# Addendum No. 06

April 11, 2024

## BAKERSFIELD COLLEGE STUDENT HOUSING (for DSA Project Name - New Residence Hall)

**PBK PROJECT NO.:** S2103400AR  
**DSA FILE NO.:** 15-C1  
**DSA APPLICATION NO.:** 02-122124

A6.2

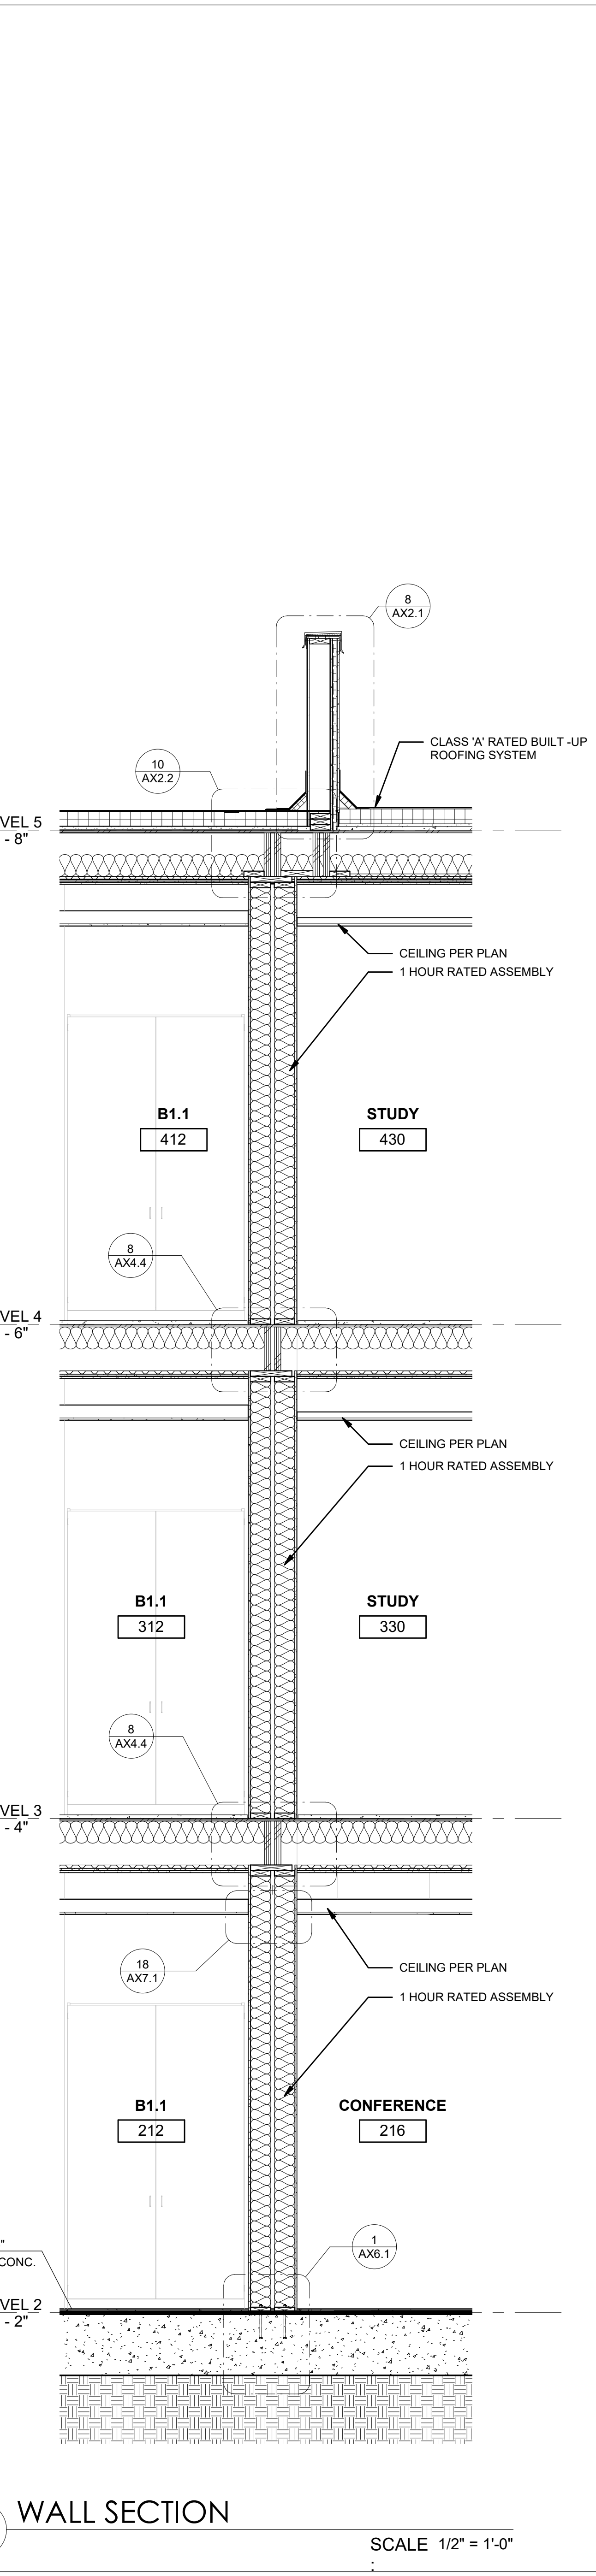
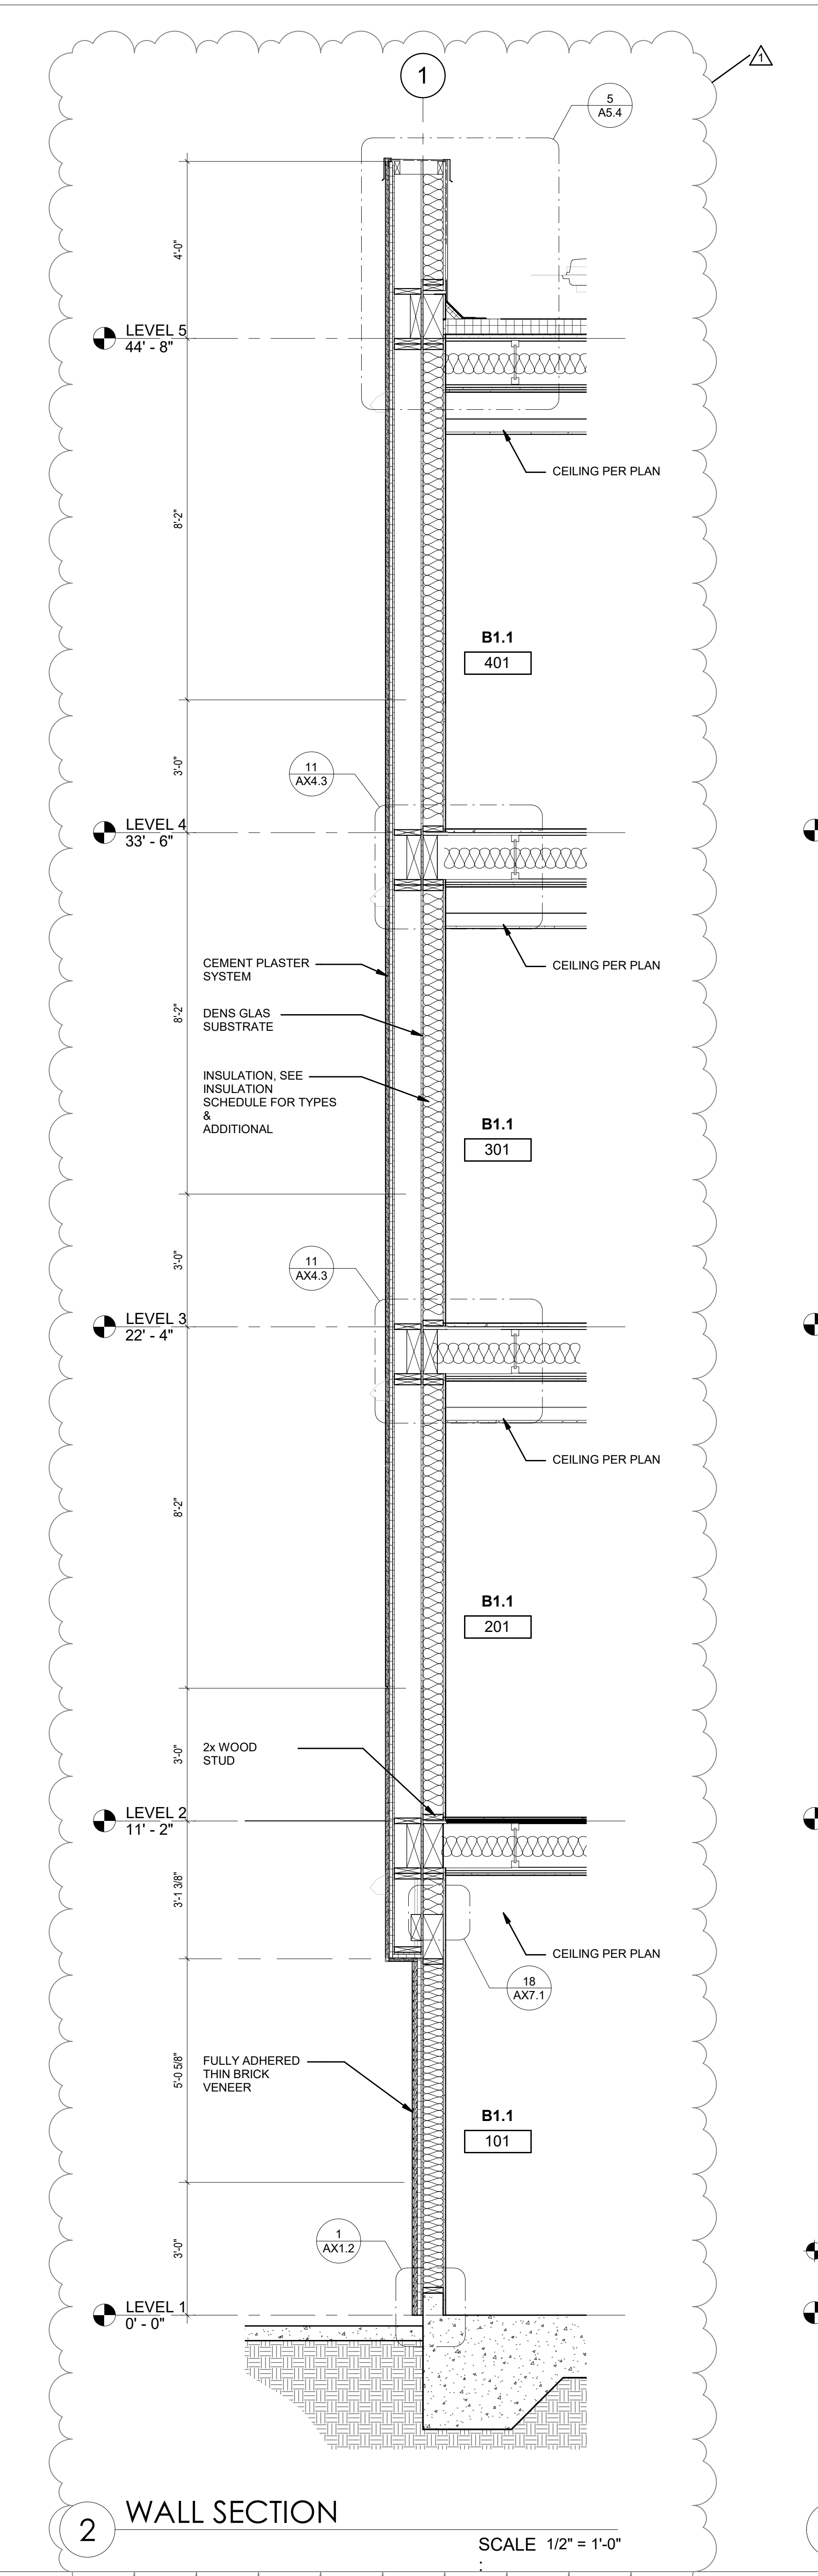
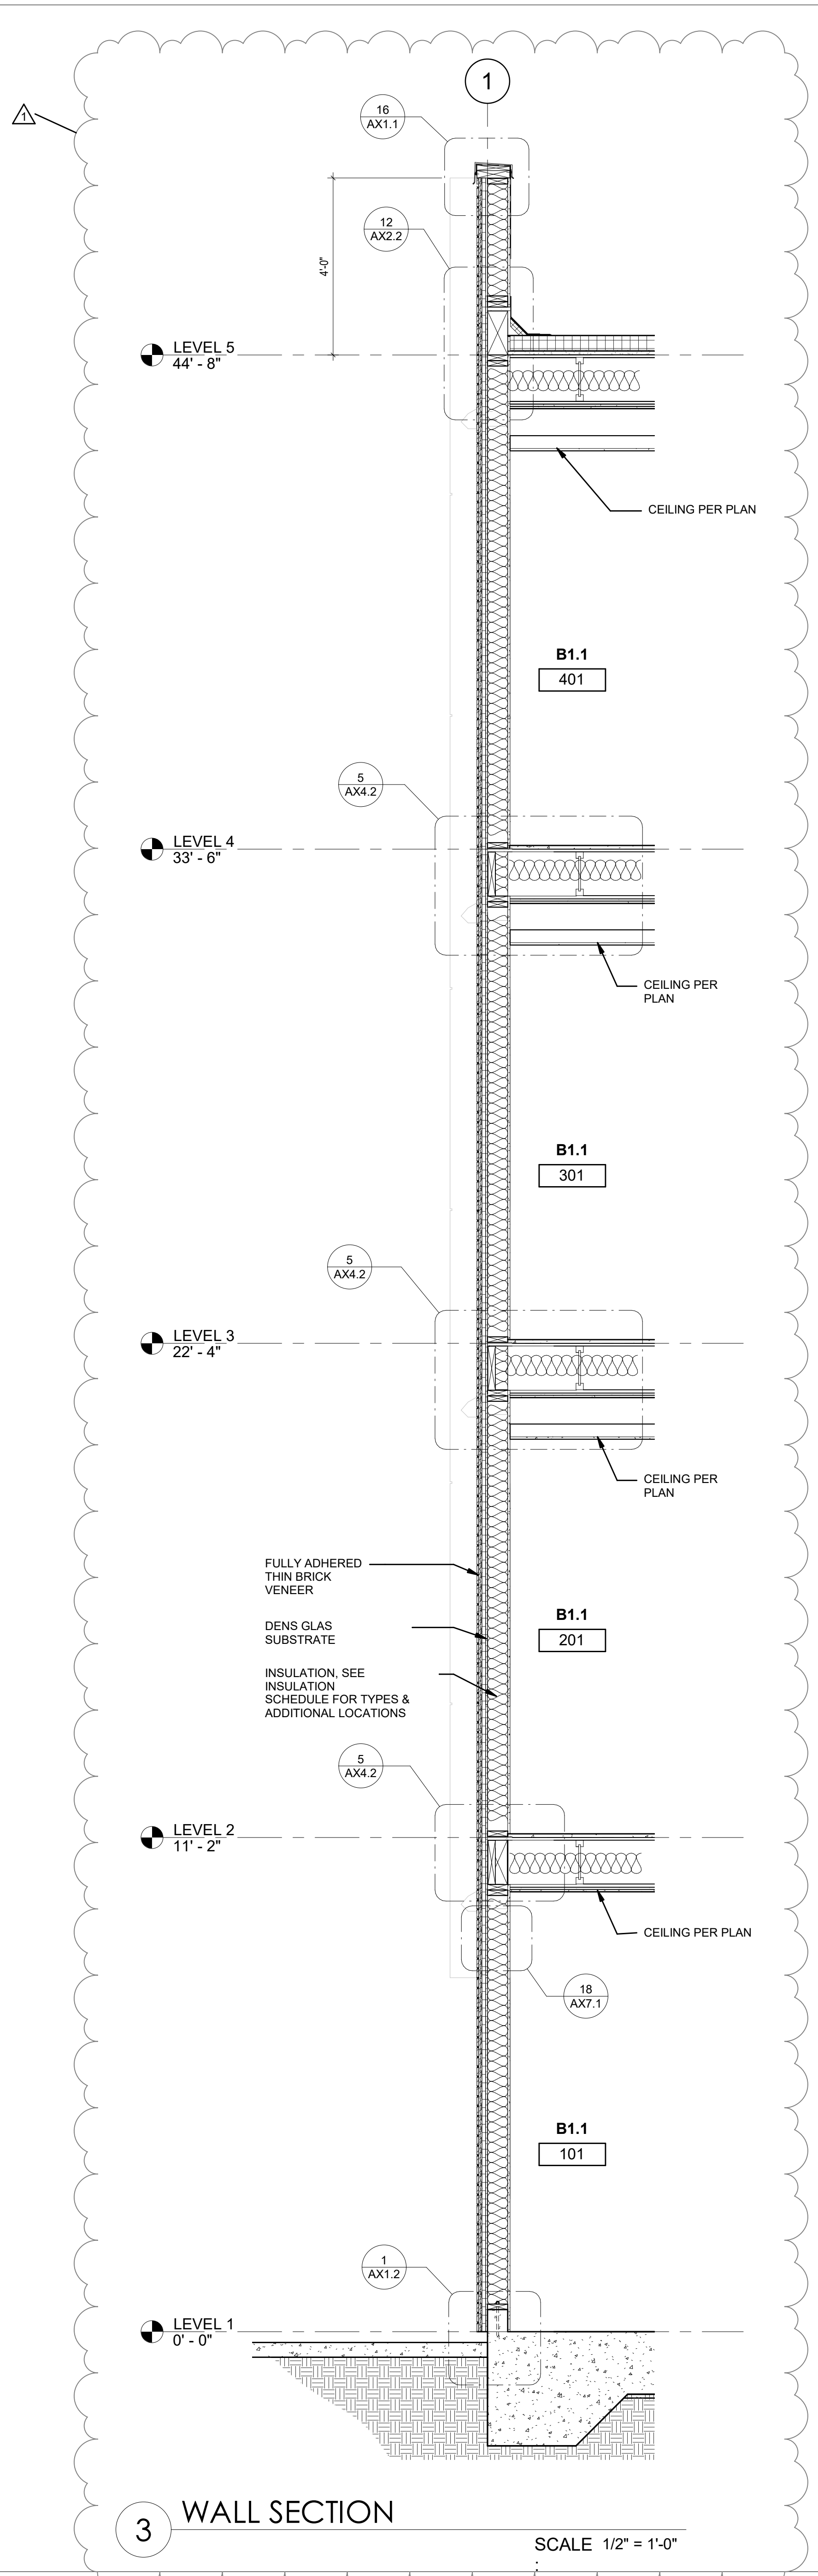
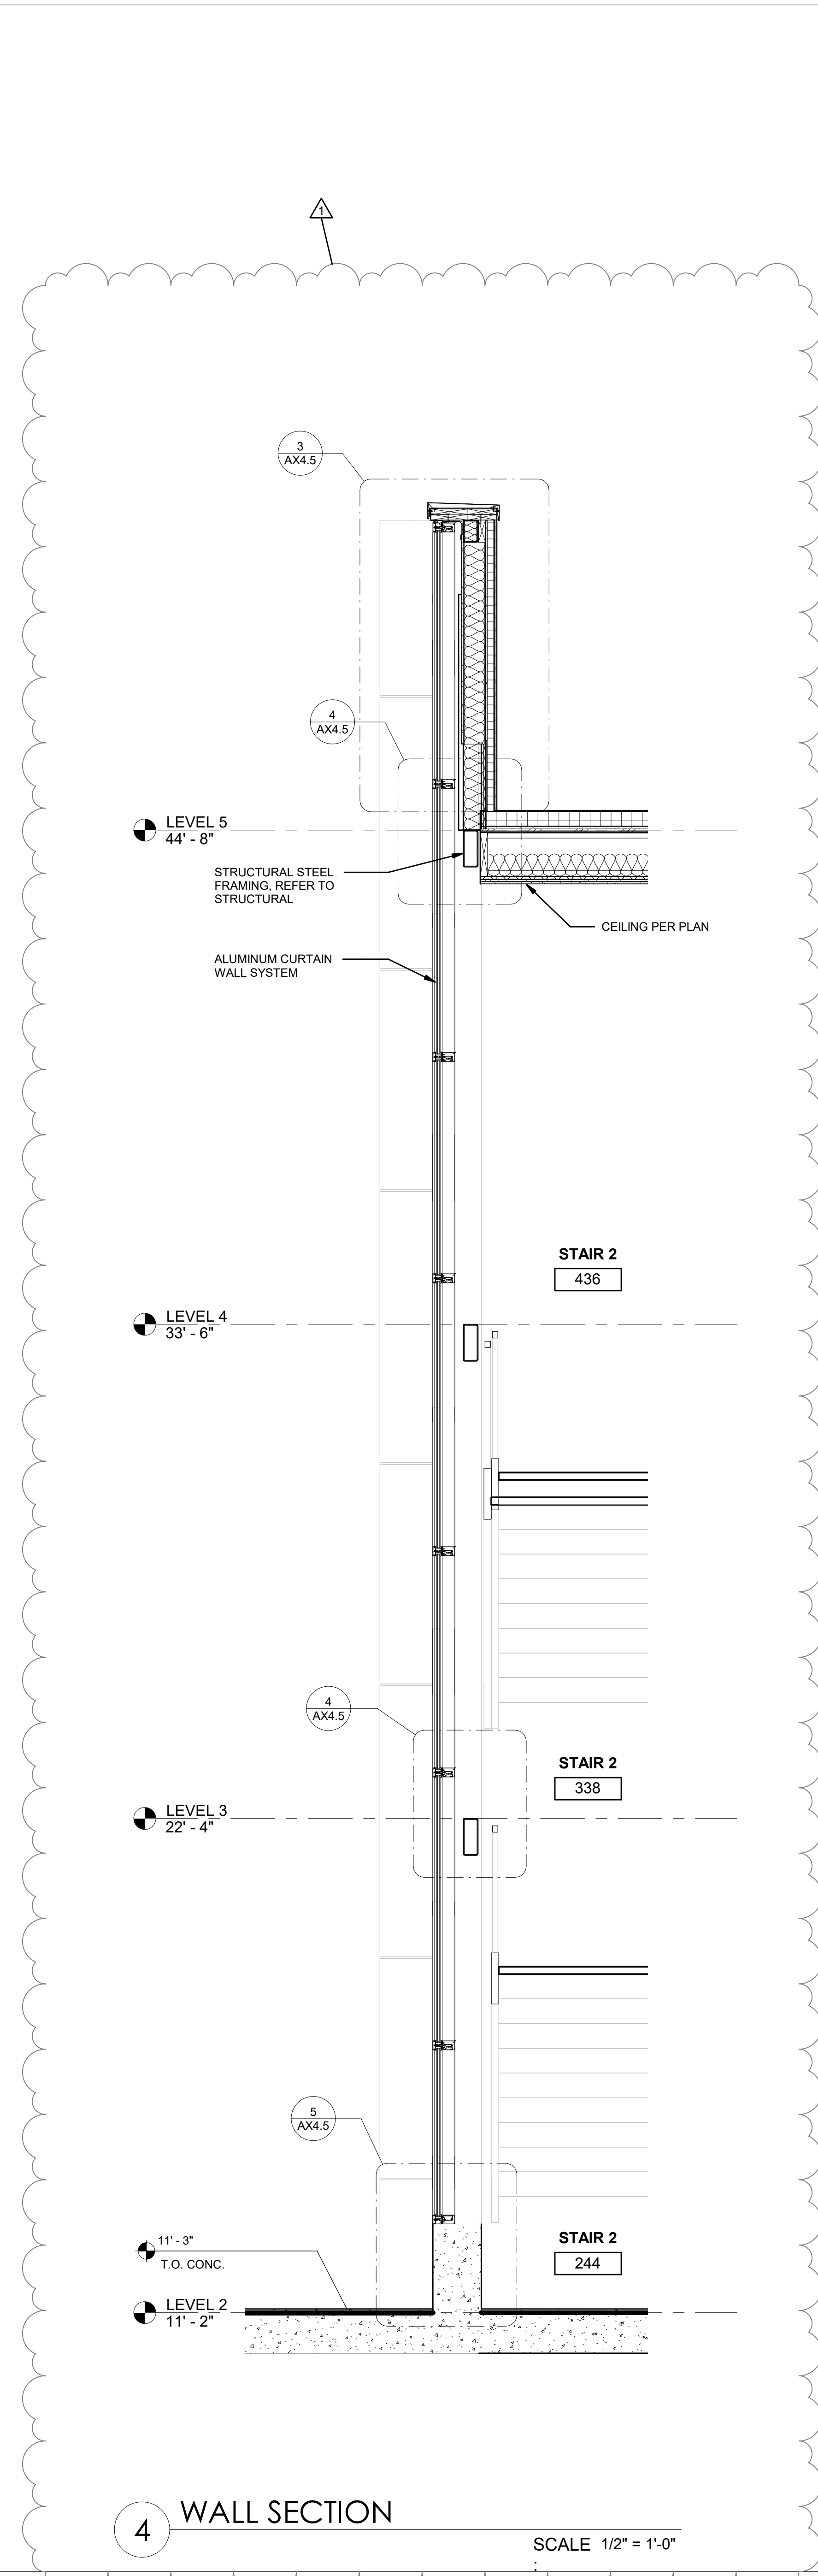
- AD6-20**    **A6.2 – Building Sections:** Replace the sheet in its entirety. Added reference note on drawings 1, 2, and 3. See attached revised drawing A6.2 with all changes clouded.
